METROPOLITAN GOVERNMENT OF NASHVILLE AND DAVIDSON COUNTY

STAFF RECOMMENDATION 906 Manila Avenue June 19, 2013

Application: New construction – Infill
District: Greenwood Neighborhood Conservation Zoning Overlay
Council District: 06
Map and Parcel Number: 08204037600
Applicant: Vickie Young & Thomas Hopper
Project Lead: Melissa Baldock, melissa.baldock@nashville.gov

403 RIGHT VIEW
SCALE----- 1/4" = 1'-0"

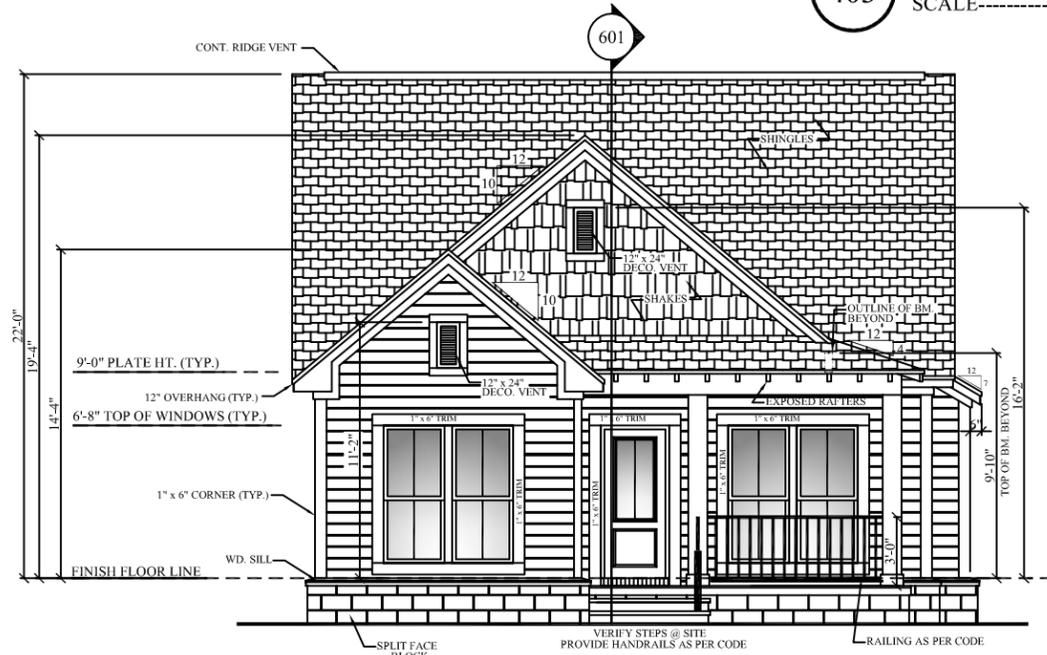
MH3C Note:
Carport is not part
of the application

401 FRONT VIEW
SCALE----- 1/4" = 1'-0"

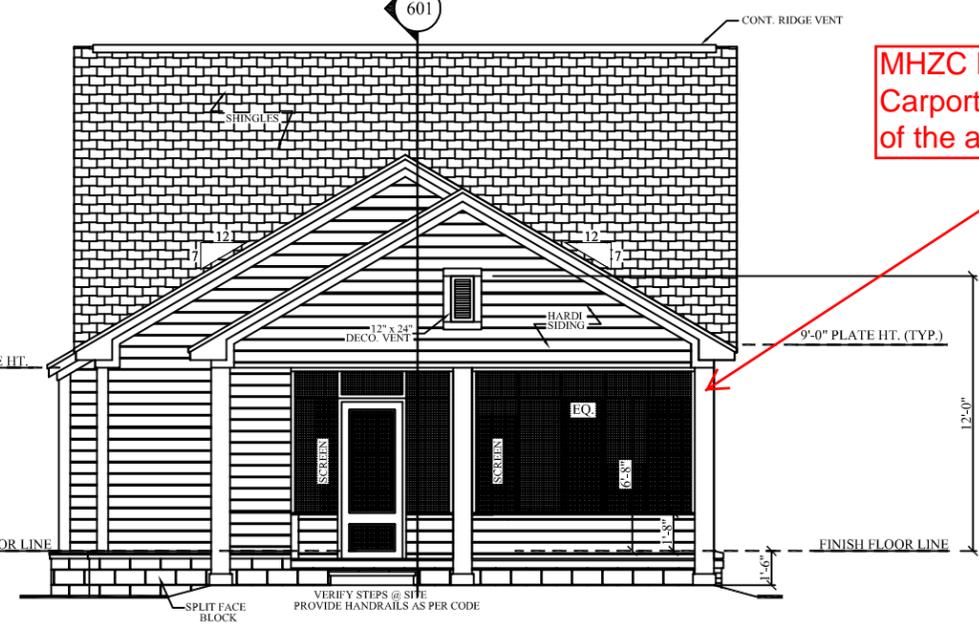
Proportion & Rhythm of Openings: The front elevation will have two sets of double windows. The primary windows are generally twice as tall as they are wide, thereby meeting typical window proportions. There are no large expanses of wall space without a window or door opening, and staff therefore finds that the infill's proportion and rhythm of openings meet Section II.B.1.g. of the design guidelines.

1. The parking pad be extended to be a driveway that goes to at least the midpoint of the house.
2. The foundation be no more than two blocks high at the front.
3. The porch columns have a cap and a base.
4. The siding has a maximum reveal of five inches (5").
5. Staff approves the shingle color, window and door specifications, porch column and floor material, and porch railing.
6. Staff approves all appurtenances prior to installation.

402 REAR VIEW
SCALE----- 1/4" = 1'-0"

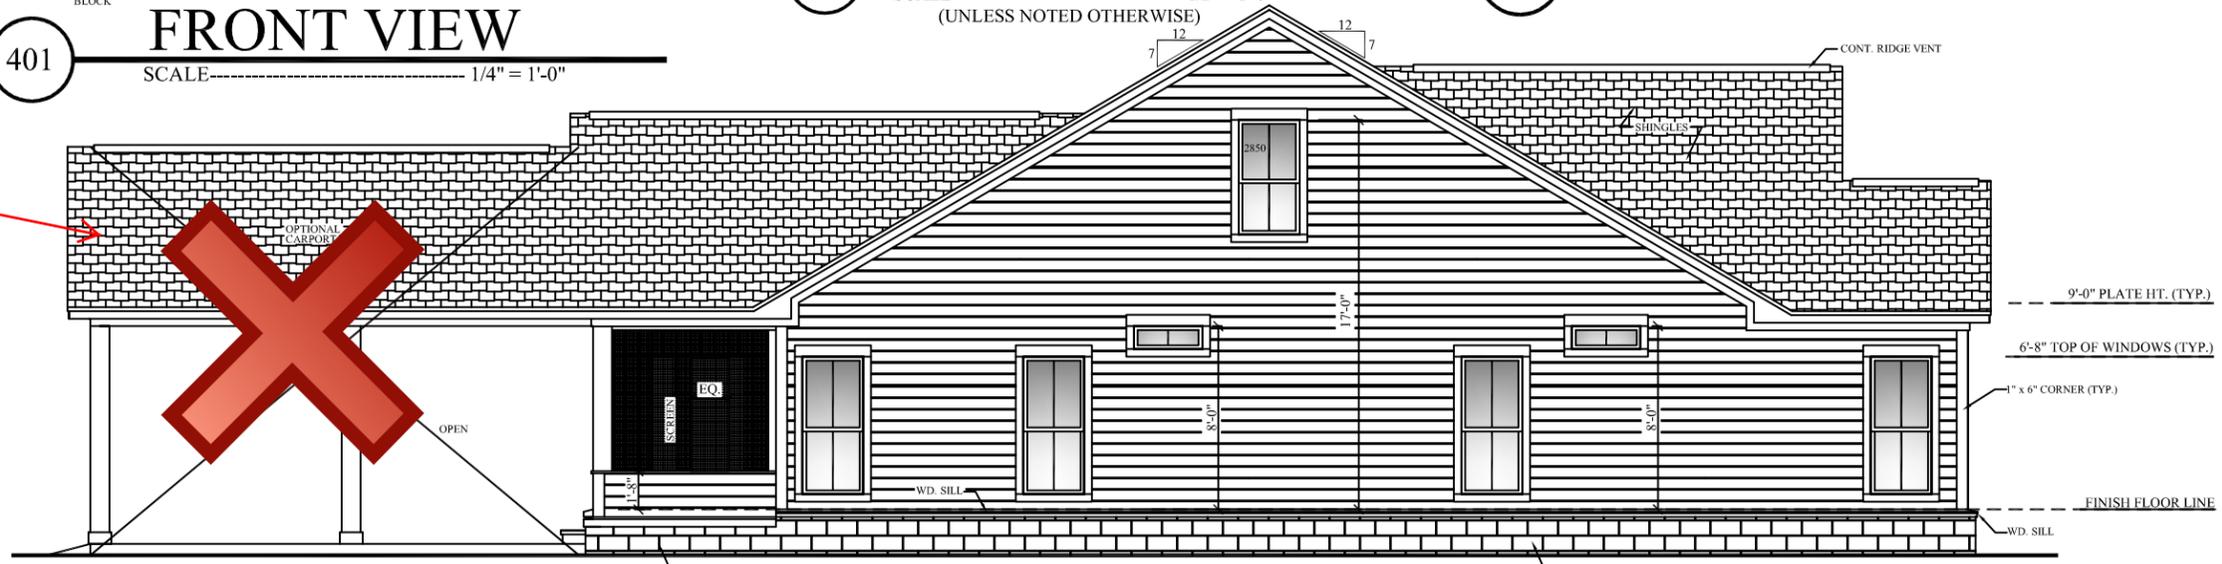
MH3C Note:
Carport is not part
of the application
